GENESEE COUNTY PLANNING BOARD REFERRALS NOTICE OF FINAL ACTION

Site Plan Review for construction of a 500,000 gallon concrete fire water storage tank, gravel access drive, accessory buildings, and associated infrastructure installation to supply water to sprinkler systems within Science & Technology Advanced Manufacturing Park (STAMP).

EDWARDS FIRE TANK

Basis of Design Report and Plans Review

TANK SITE PLAN

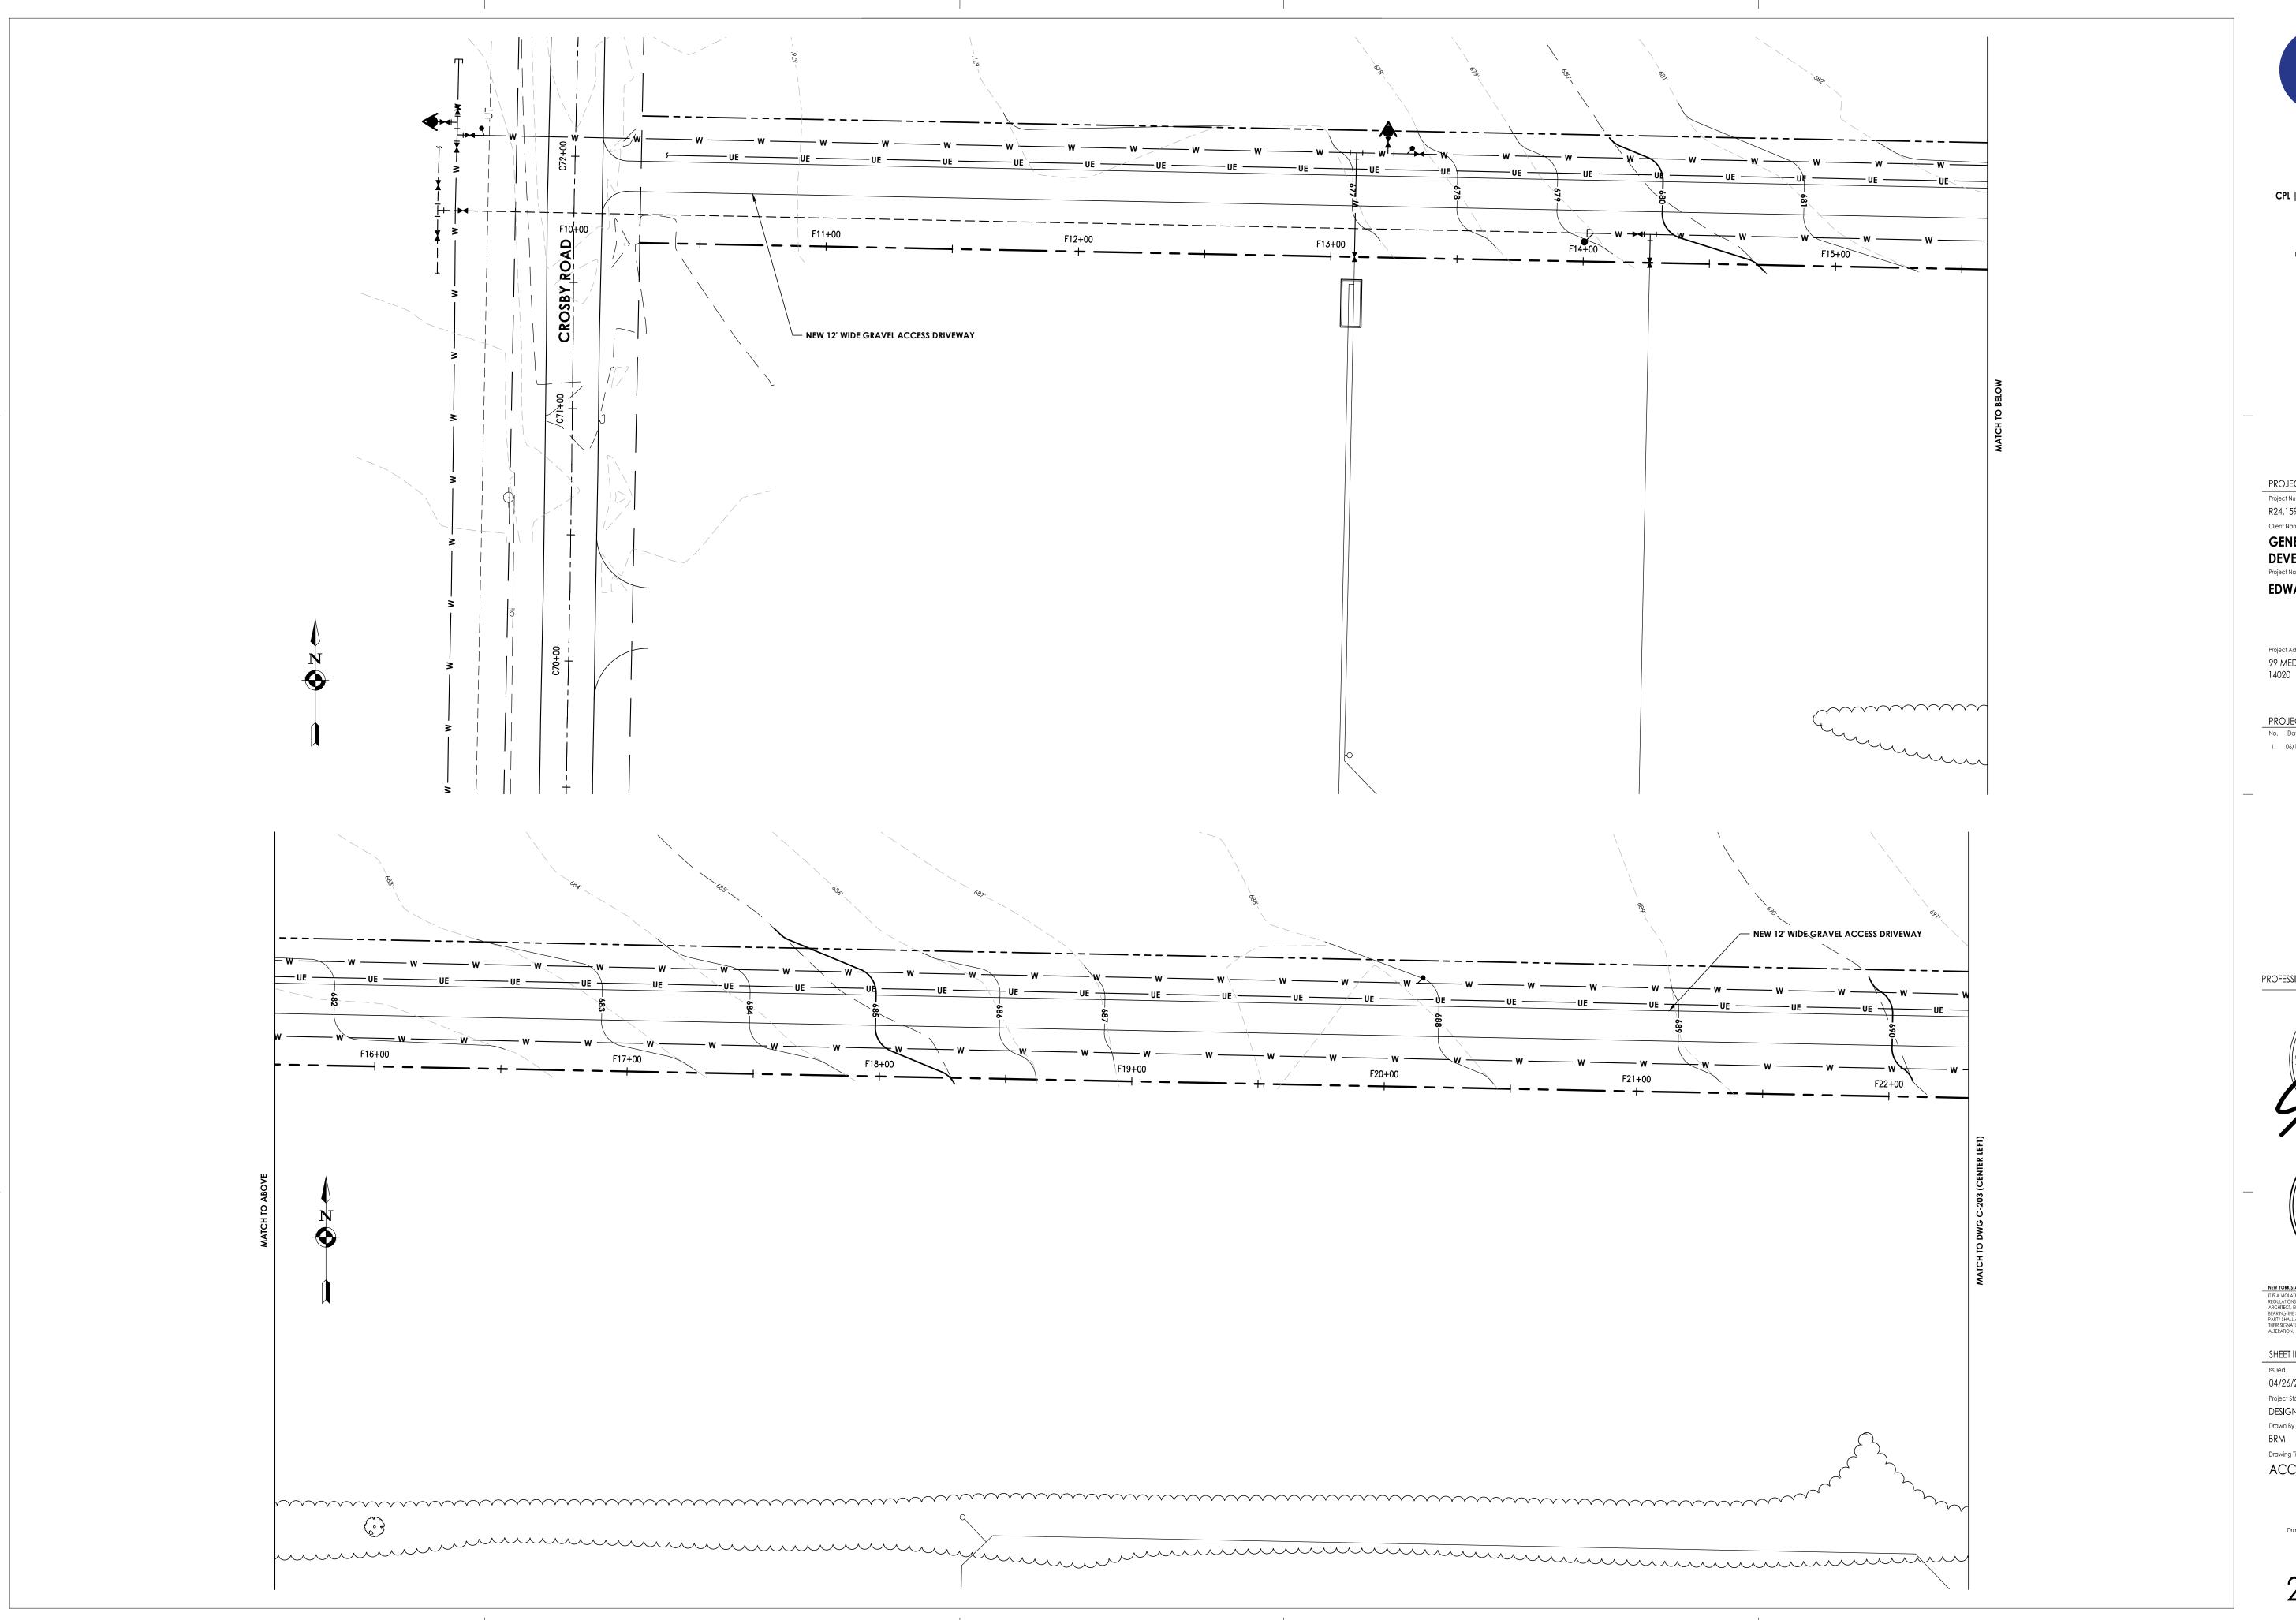
- 5. What is the finish (aggregate?) for the proposed above ground control building? What will it look like?
 Response: We are using the Lakelands Versa-Set Flat Roof style building as the basis of design. The control building will have a similar appearance to the
- 6. Are you proposing chain link fence around the tank site?

Response: The security fence as shown on the plans (C-201) will be chain-link with barbed wire as shown in the details (C-303).

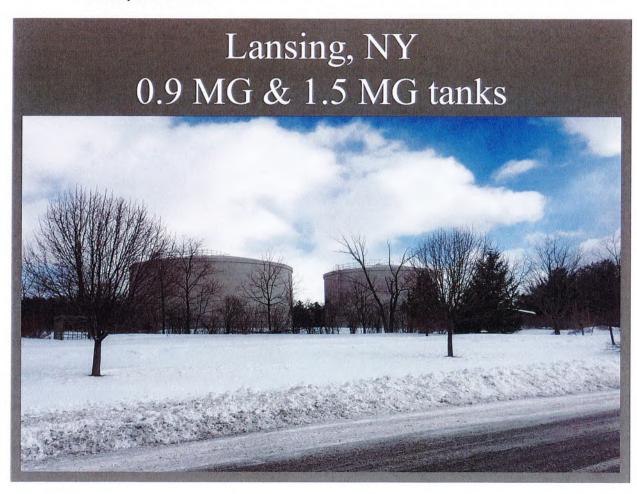
- What is the color of the tank? Please provide a color sample.
 Response: The tank color will be selected to compliment the colors of the Edwards Facility. Please refer to the attached color chart from Euclid Chemical Company as provided by DN Tanks, one of the potential tank manufacturers.
- What is the color of the roof of the tank? Please provide a color sample. Response: The tank roof color will be the same color as the walls, selected to compliment the colors of the Edwards Facility. Please refer to the attached color chart from Euclid Chemical Company as provided by DN Tanks, one of the potential tank manufacturers.
- 3. What is the approx. wall thickness of the tank?

Response: The tank wall thickness varies based upon the height location, there is a minimum thickness of 4-1/2" concrete panel, which is then wrapped with wire and shot-crete. The final thickness varies from 7-8" near the roof and 10-12" at the base.
- 4. Is there any landscaping planned for the site? **Response: No landscaping is planned at this location.**
